IEEE C802.16j-07/227r1

Project **IEEE 802.16 Broadband Wireless Access Working Group** <<http://ieee802.org/16>>

Title **Reliable Multicasting with Selective Acknowledgement for IEEE802.16j**

Re: A response to the call for technical proposals for the Relay TG, see IEEE 80216j-07/007r2.pdf

Figure XXX, RMM-ARQ transmit block states

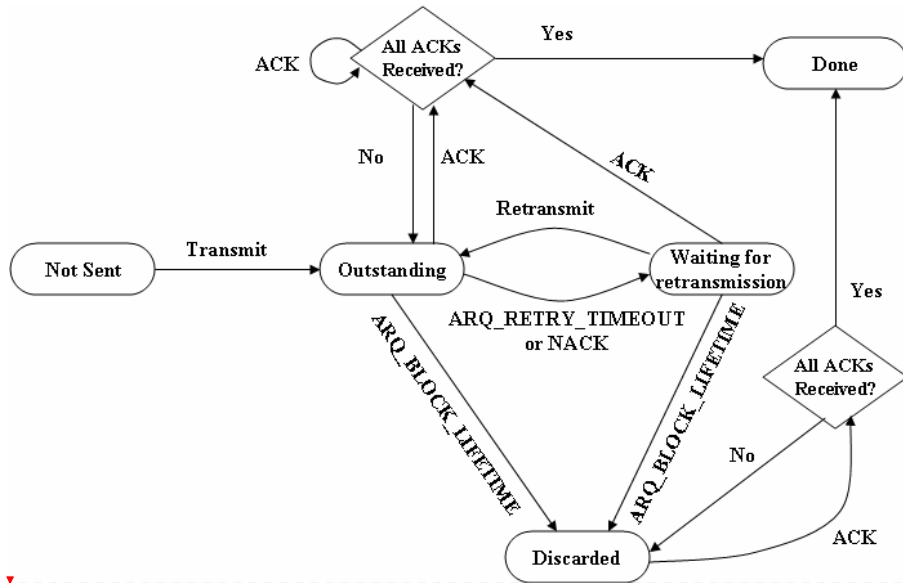
6.3.13.2.1 Transmitter state machine for RMM-ARQ

The RMM-ARQ transmitter state diagram in Figure XXX is very similar to the ARQ transmitter state diagram in Figure 33, with the difference that a packet must receive ACK from all critical RSs before transitioning to “Done” state. As long as there is/are ACK message(s) pending from at least one of the RSs, the block stays in the “Outstanding” state.

There is no transmitter-initiated reset mechanism (i.e., as in Figure 34) for RMM-ARQ for the synchronization of transmitter and receiver windows. If the ARQ TX WINDOW START is not updated for a certain period of time and the timer exceeds ARQ SYNC LOSS TIMEOUT, the BS removes the lagging RS(s) from RMM-CRS mode and places them into RMM-NCRS mode. When no RS is in RMM-NCRS state, the transmitter state machine reduces to the one used in the DMM connections.

Figure YYY RMM-ARQ block reception

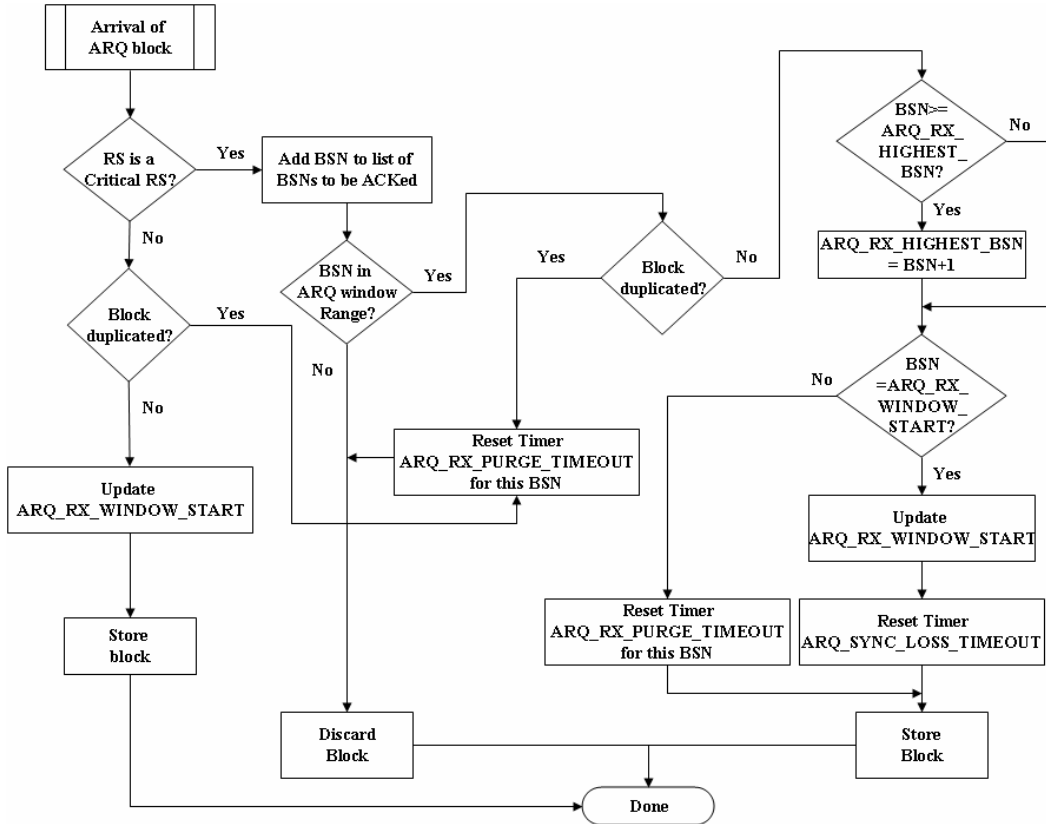
6.3.13.2.2 Receiver state machine for RMM-ARQ

For RMM-CRSs, the RMM-ARQ receiver state diagram in Figure YYY is the same as the ARQ receiver state diagram in Figure 36. On the other hand, if a RS is RMM-NCRS, it is still required to keep track of the ARQ_RX_WINDOW_START so that it may easily switch to RMM-CRS mode if needed. Moreover, duplicate packets are detected and discarded.

There is no receiver-initiated reset mechanism (i.e., as in Figure 35) for RMM-ARQ for the synchronization of transmitter and receiver windows. If the ARQ_RX_WINDOW_START is not updated for a certain period of time and the timer exceeds ARQ_SYNC_LOSS_TIMEOUT, the RS decides to switch from RMM-CRS mode to RMM-NCRS mode. RS should inform MMR-BS and receive confirmation from MMR-BS before completing the switching to RMM-NCRS mode.
